APPENDIX A1: Consultation Responses

I am writing to OBJECT to the proposed development of Marlow Film Studios at Little Marlow Lakes Country Park (22/06443/FULEA).

Figure 3: Westhorpe Interchange – Study Area

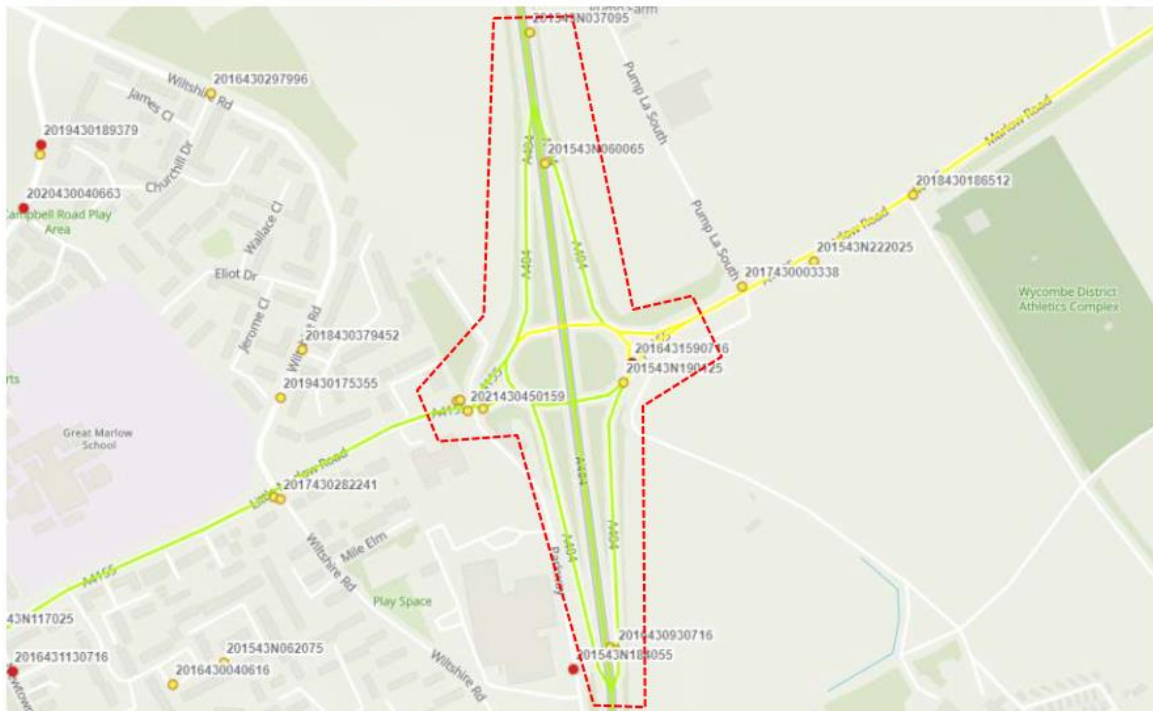
During the seven year period 10 PIA’s were noted at the junction of which nine were categorised as slight and one serious. The serious collision occurred in 2016 and was a shunt type collision.

Figure 1: Marlow and Little Marlow Walking Isochrones – Offsite Parking Monitoring

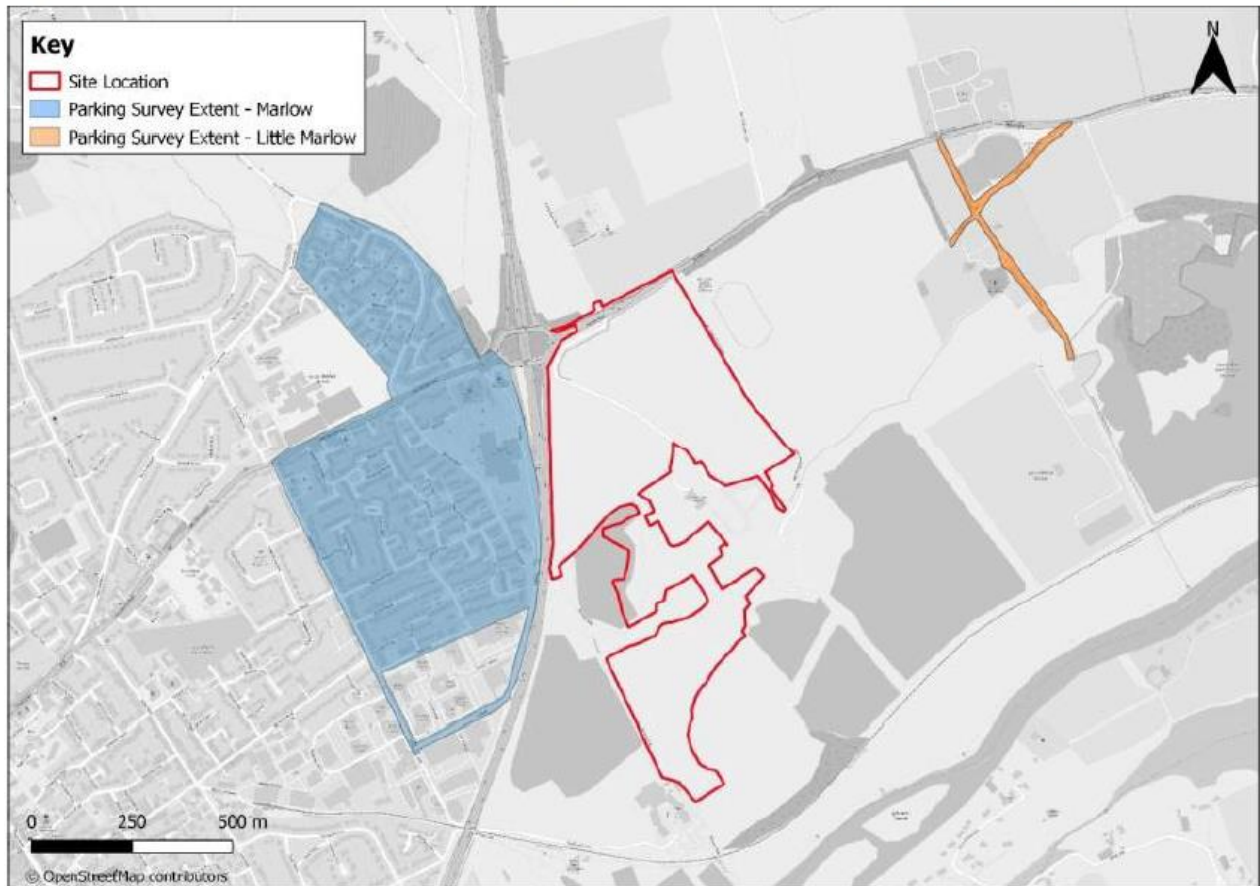
It is proposed that the streets identified in the highlighted area would be subject to an on-street parking survey on a neutral weekday (Tuesday, Wednesday and Thursday) between 1400 and 1600 to establish the baseline position of on-street parking. It is then proposed that annual surveys of the same streets at the same times would be undertaken in order to identify whether on-street parking conditions have changed. If there is an identified change in conditions then further surveys would be needed in the identified areas to determine whether the changes relate to the site. It is suggested that this could be done through surveys of pedestrians arriving at the site on foot and through observations.

Figure 4: Principal Pedestrian and Cycle Routes Plan

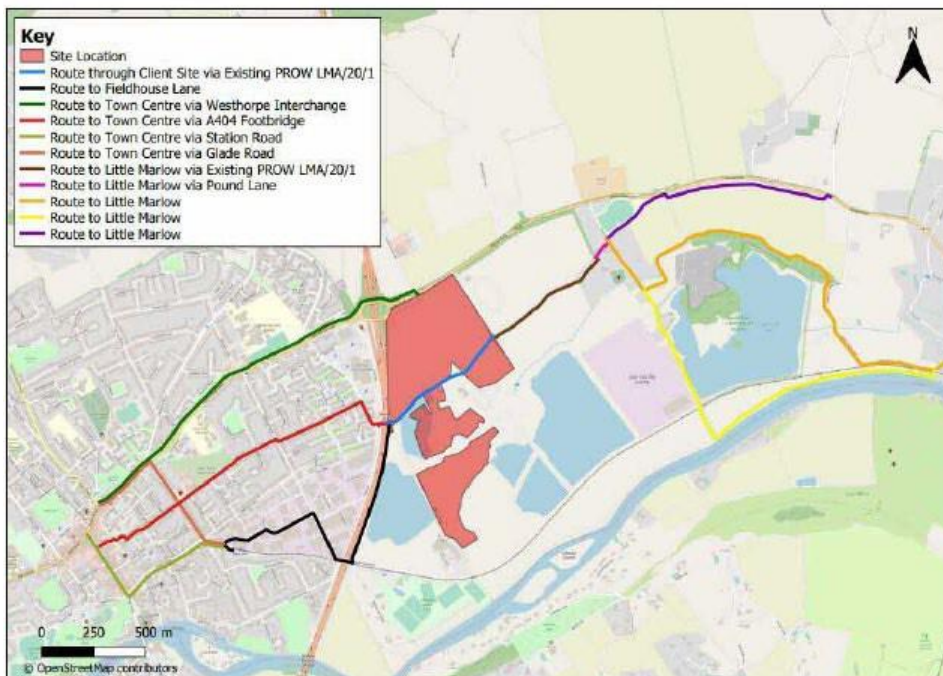
The applicant has considered the walking and cycling journey times from different zones within Marlow and the site via the proposed links to the west of the site. Three main routes

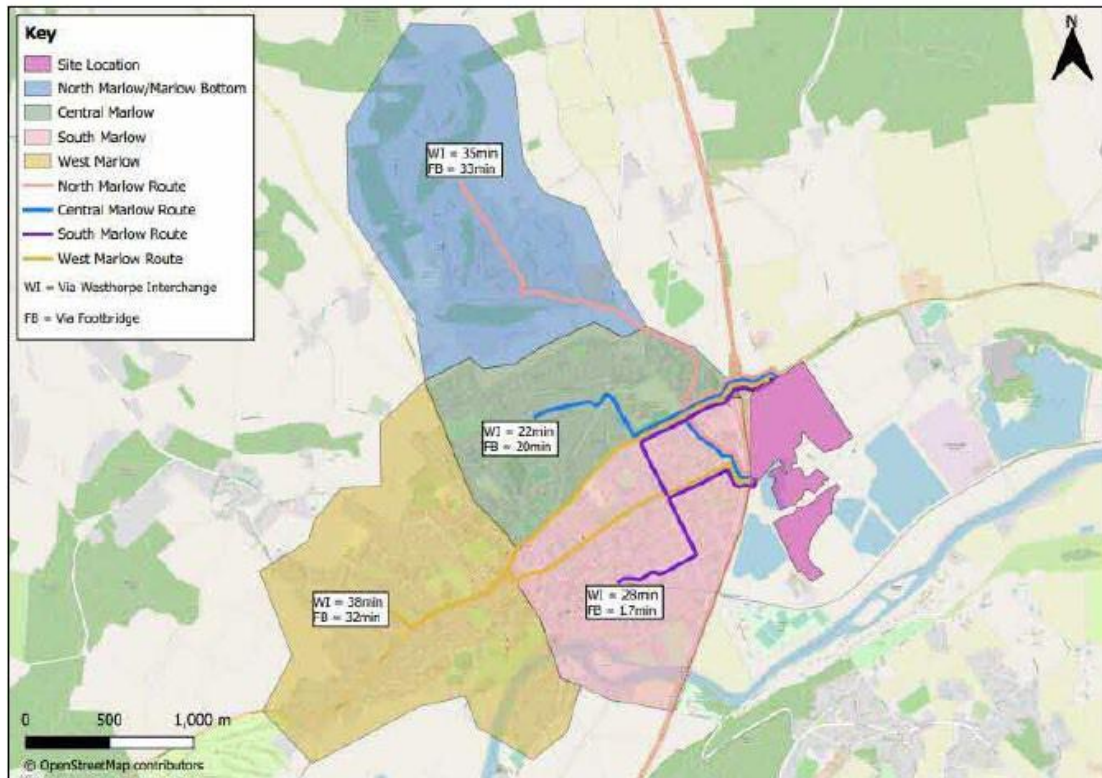
I have reviewed the routes and associated journey times and I have the following points to raise:

- It would seem that the route via A4155 and Westhorpe Interchange is always going to be a desire line.

Figure 6: Pedestrian Journey Times from Marlow via Proposed Access Points

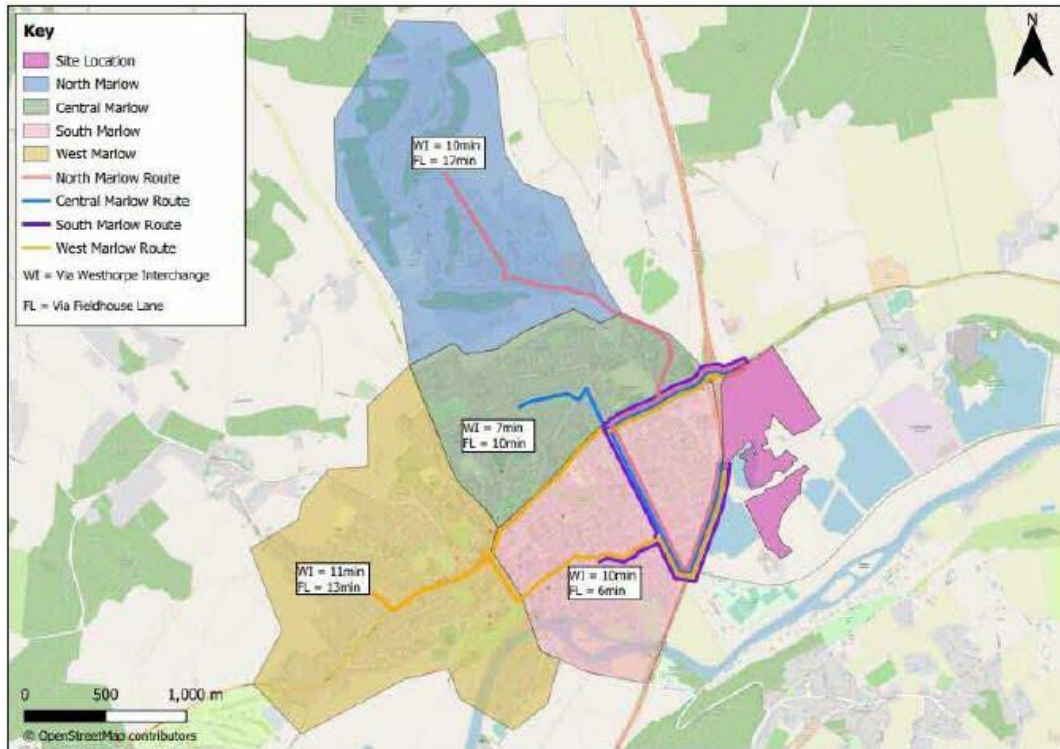
I have reviewed the routes and journey times provided and have the following points to raise:

Figure 11: Modal Split (2019 – 2022): SOV and Sustainable Modes Amalgamated – Milton Park

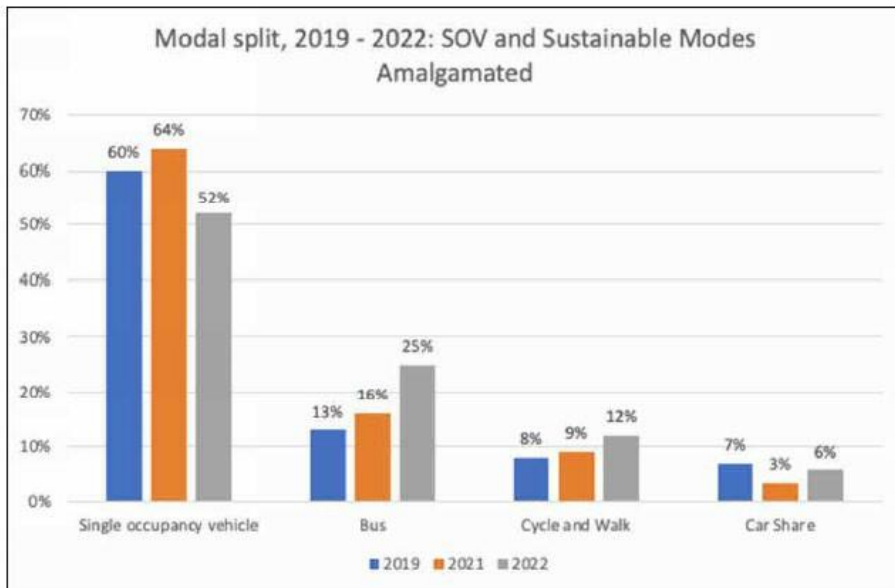
- The table does show that single car occupancy has risen and then fallen, but by only 8% and the use of sustainable forms of transport has risen. However this doesn't really show any long term patterns.
- Due to the difference in usage of this site when compared to the MFS site it is difficult to determine whether such measures would have a similar impact for the MFS site.
- Does the applicant know whether the Milton Park site is relying on the success of the sustainable transport measures to mitigate what would otherwise be an unacceptable impact on the highway network or whether the measures are purely aimed at achieving a sustainable development, consistent with government policy.

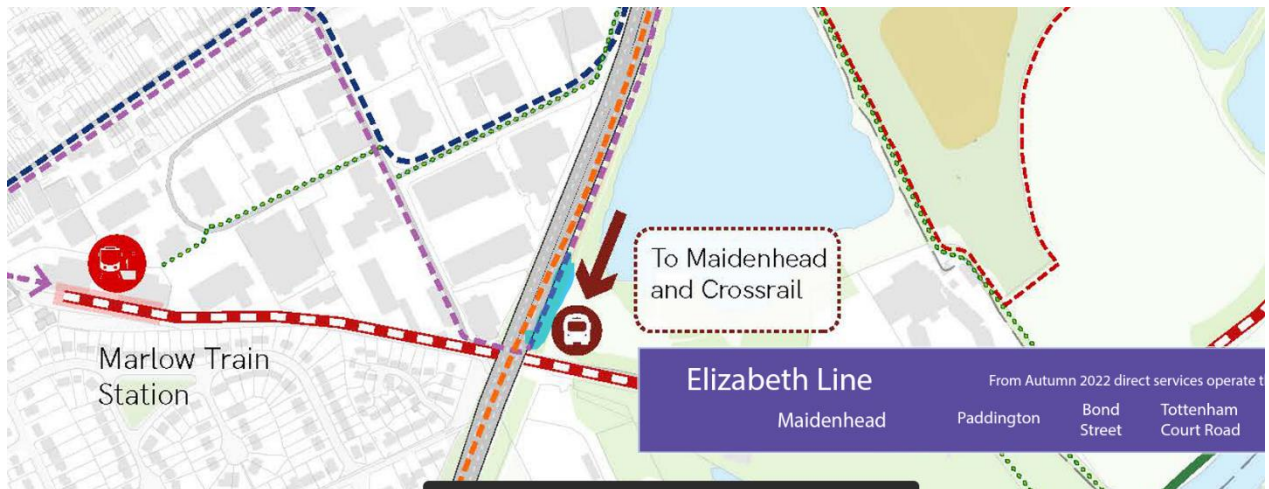
The green arrow passes across the Volvo Footbridge [this isn't PROW, though is marked as such] and is for walking only. You'll note I have made enquiries with National Highways as to the public rights across the bridge. While not guaranteed, there seems to be some assurance of future maintenance and provision by National Highways and further enquiries by the applicant may reveal an obligation to provide pedestrian access across the bridge in perpetuity, thus ensuring the development's future sustainability.

Ideally, this bridge would be upgraded for cycling and disabled access through developer contributions, but this is a decision for Highways Development Management, looking at the site's sustainability as a whole, including suggested enhancements for vulnerable users to safely negotiate the Westhorpe roundabout. Nevertheless, developer-funded bridge upgrades for use by cyclists and disabled users is something I would support.

Average Queue Length - J4 - A404 NB OFF SLIP

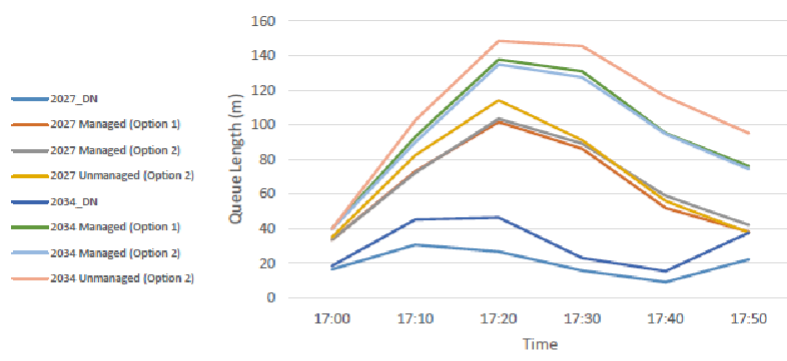
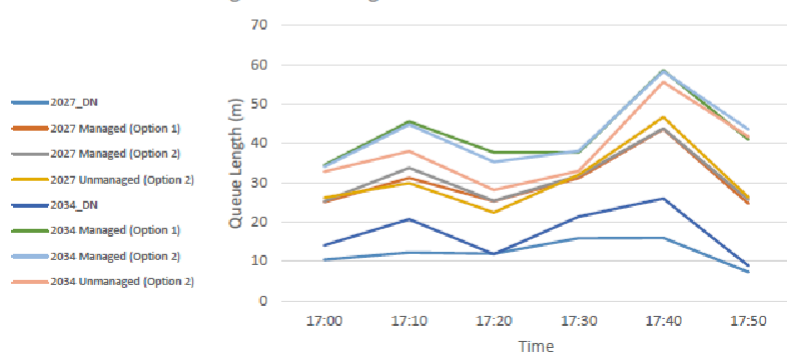
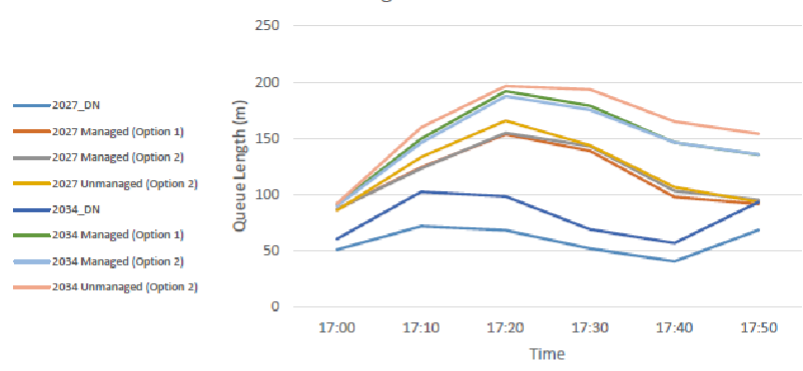
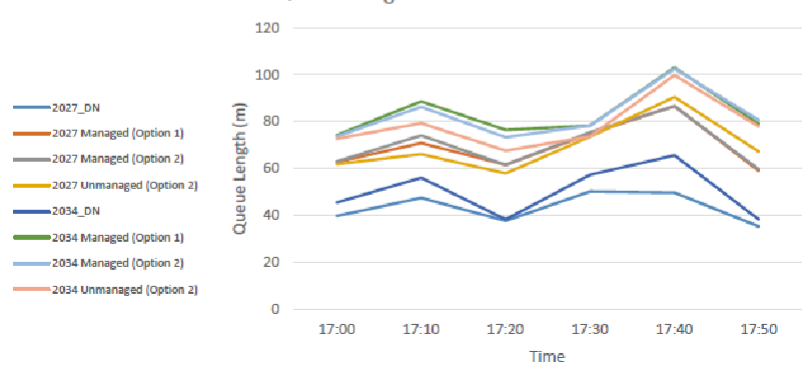
- 47 Overall there has been an improvement in queues on both A404 SRN off-slips following representation of MOVA control into the VISSIM model.
- 48 The stacking capacity for the NB offslip is around 370 meters and for the SB offslip around 250 meters (measured from the model). As seen in the graphs below for maximum and average queue lengths, in the AM peak 2034 Unmanaged Option 2 scenario, the queues are much lower than the reference case, especially for the NB offslip, and remain below capacity. In the PM peak 2034 Unmanaged Option 2 scenario, the queues are higher than the reference case but remain well within stacking capacity of the offslips.
